PROJECT: DURANGO DRIVE - WESTCLIFF TO VEGAS

30% PRELIMINARY DESIGN SUBMITTAL

**RESPONSE TO COMMENTS
ON THE
30% DRAINAGE REPORT
AND 30% IMPROVEMENTS**

**Subject: Response to Comments on the Durango Drive –
Westcliff Drive to Vegas Drive 30% Drainage Report and
30% Improvements**

Revised Figure 7

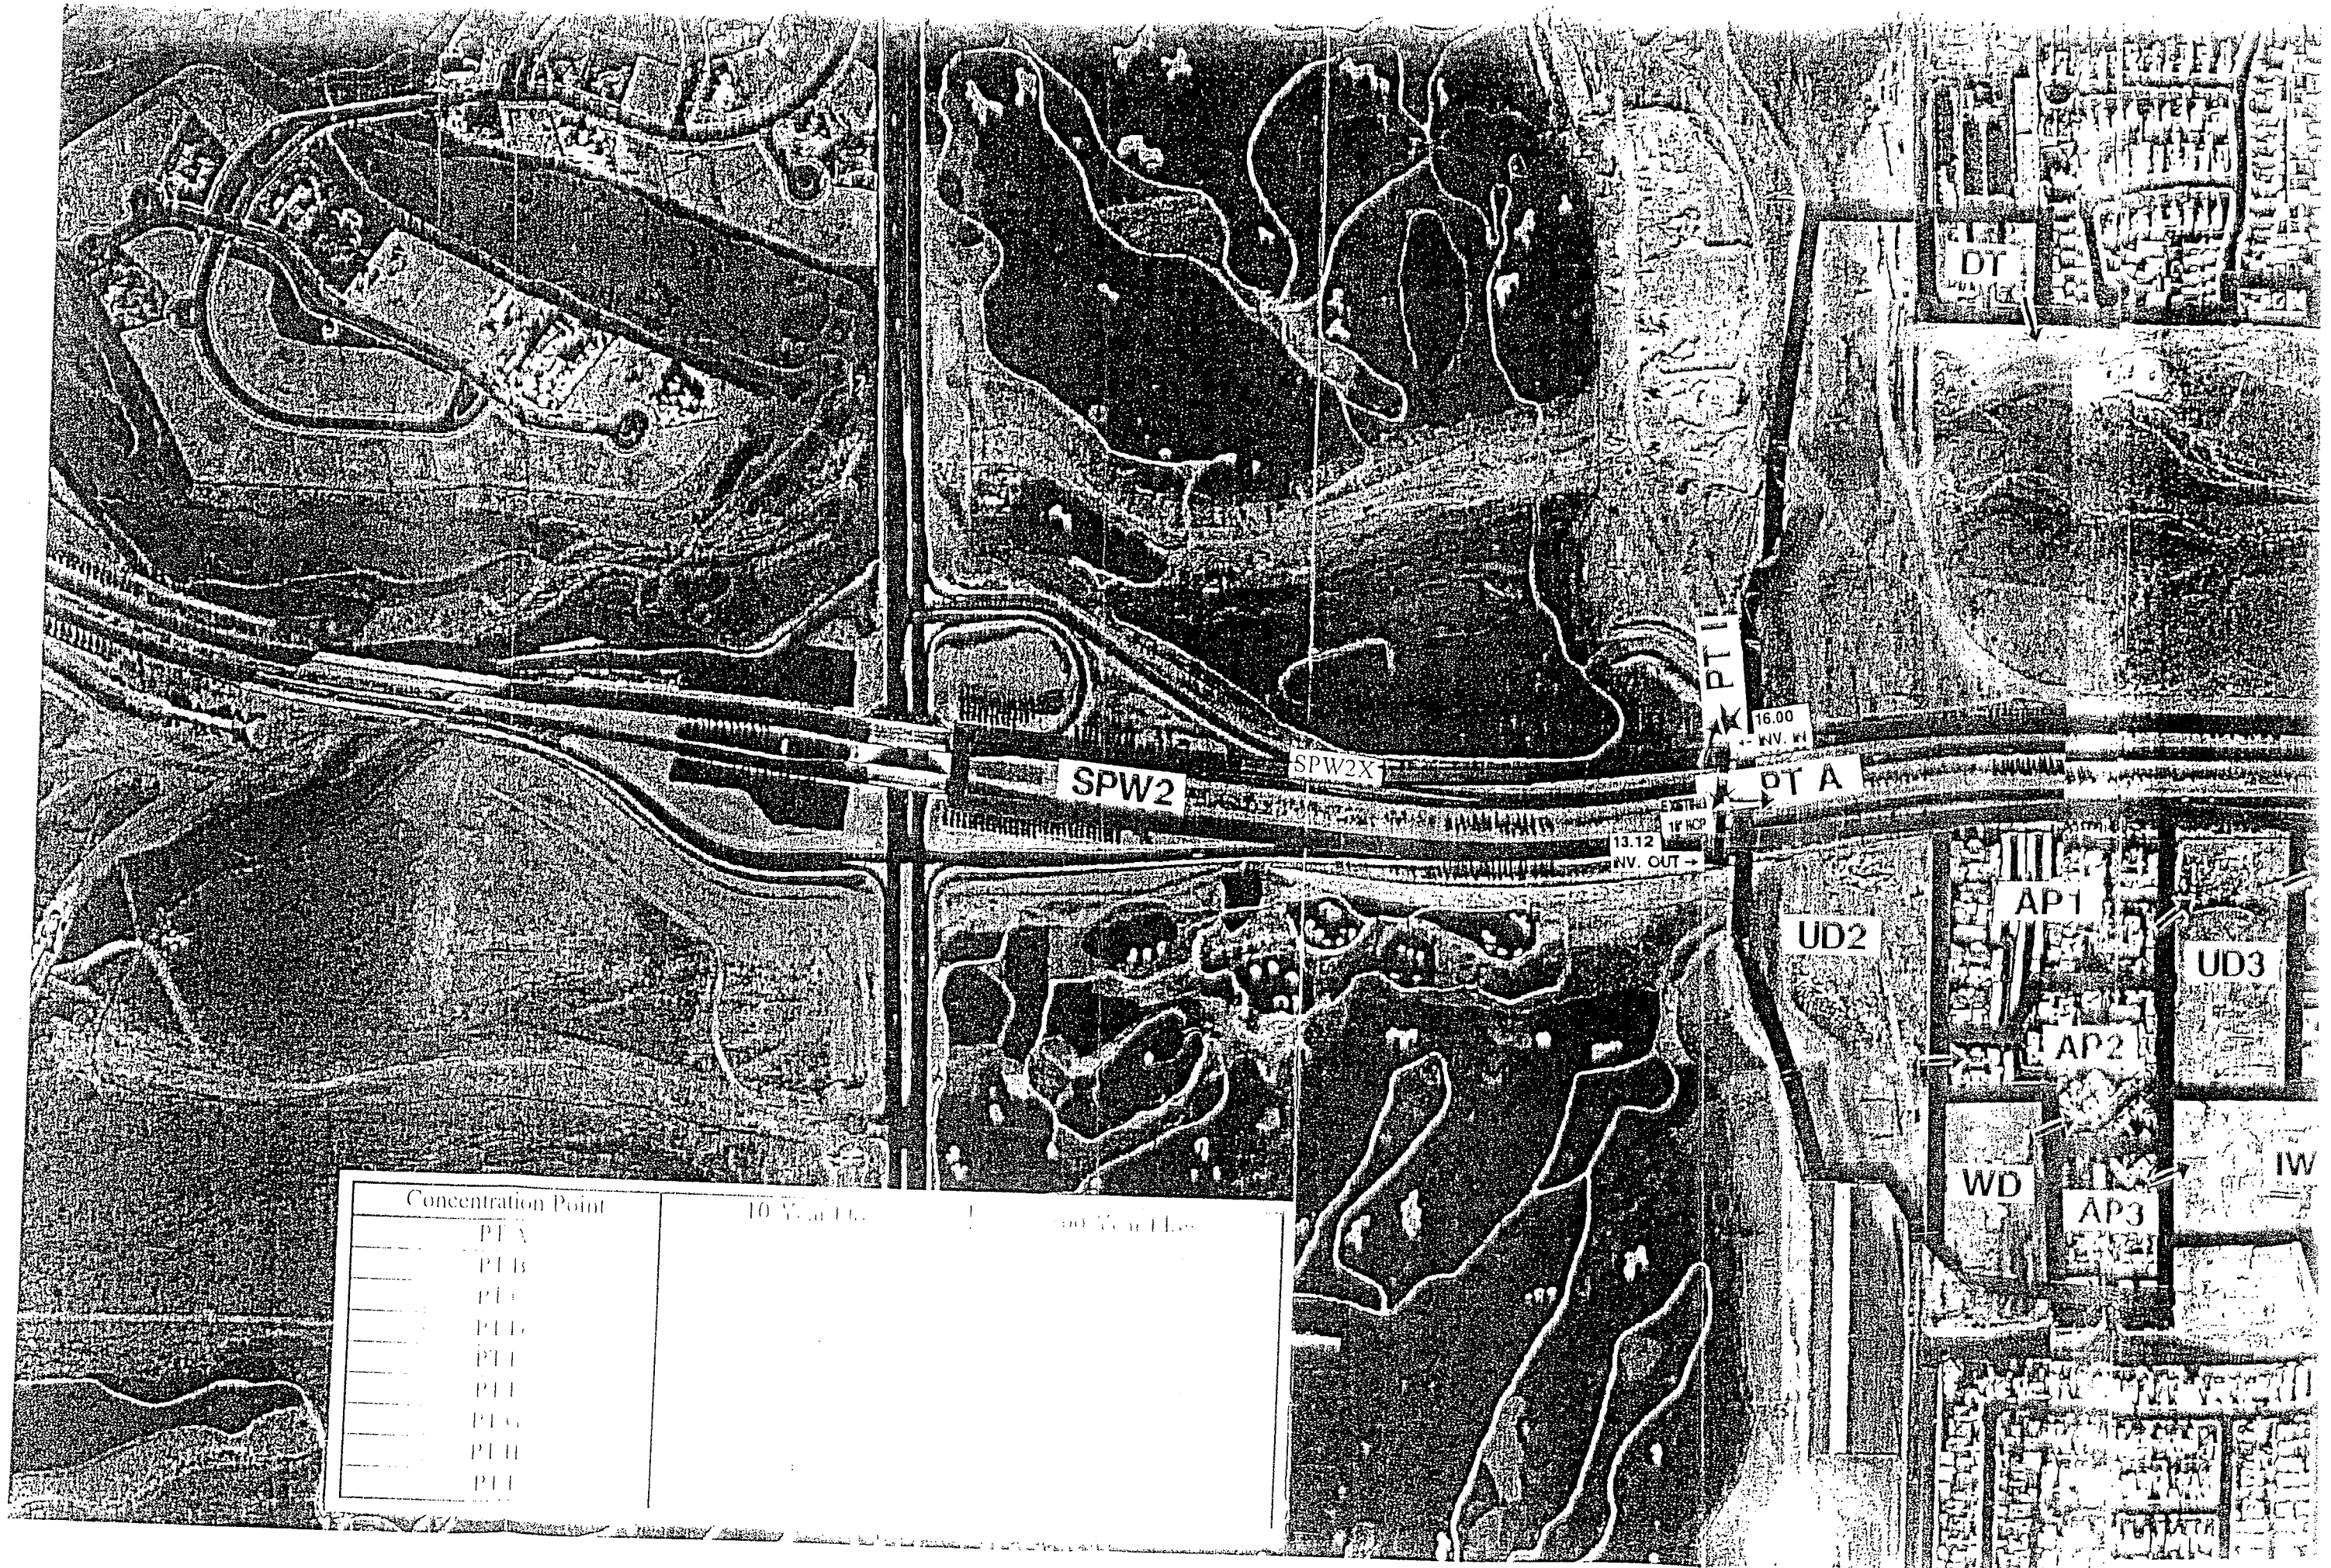
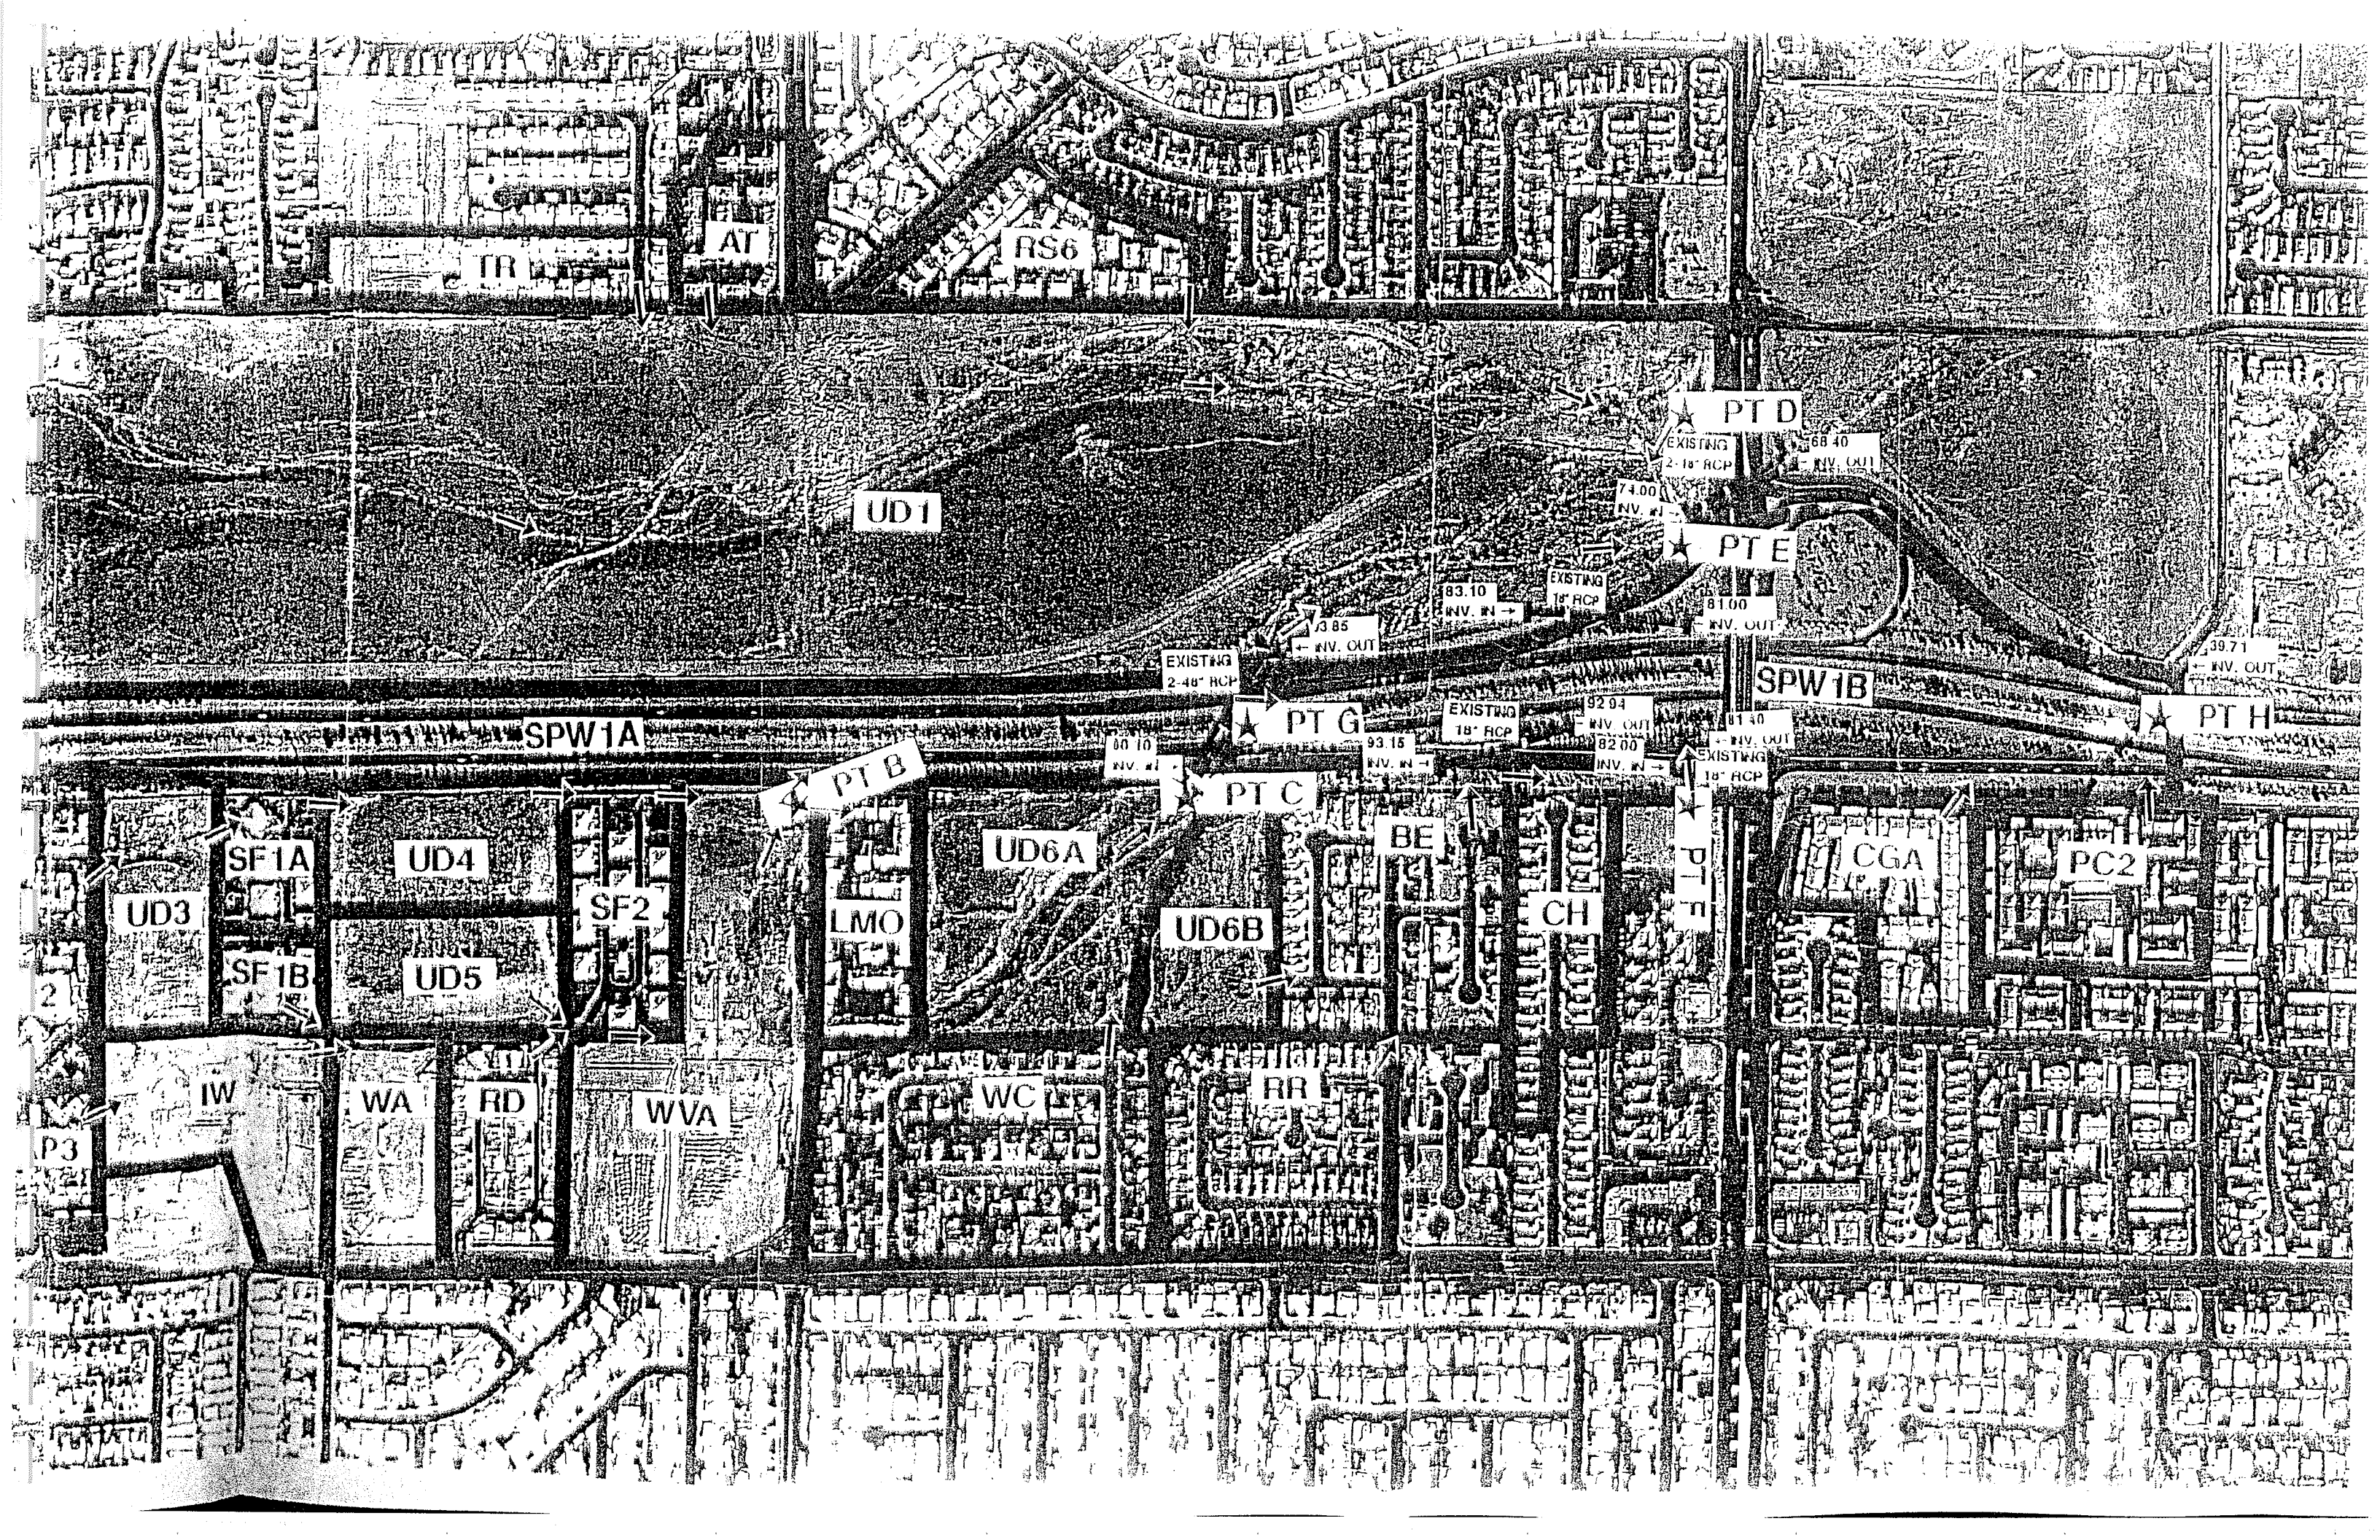
Comment: "8. Revise Figure 7, Storm Drain Facilities to reflect the revised storm drain system proposed for this project."

Response: Figure 7 has been revised to reflect the revised storm drain and drop inlet layout.
